Project
60 Whitfield Street

Proposed Elevation -
Whitfield Street

60WS-A-SBA-DR-XX-4006-C3

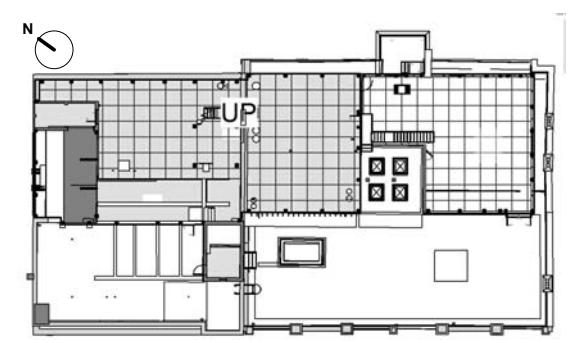
- 1 Louvre added to enclose MEP
- 2 Existing enclosure of Goldbeaters atrium is retained except two lateral walls
- 3 Scope of demolition of existing plant room on Walport building increased
- 4 Minor repositioning of approved flues
- 5 Maintenance cat ladder added to link Goldbeaters terrace with Walport terrace
- 6 Amended stair-landing levels
- 7 Parapet of dumbwaiters enclosure raised by 235mm
- 8 Reduced louvre height to match Howland Mews elevation
- 9 One section of window removed
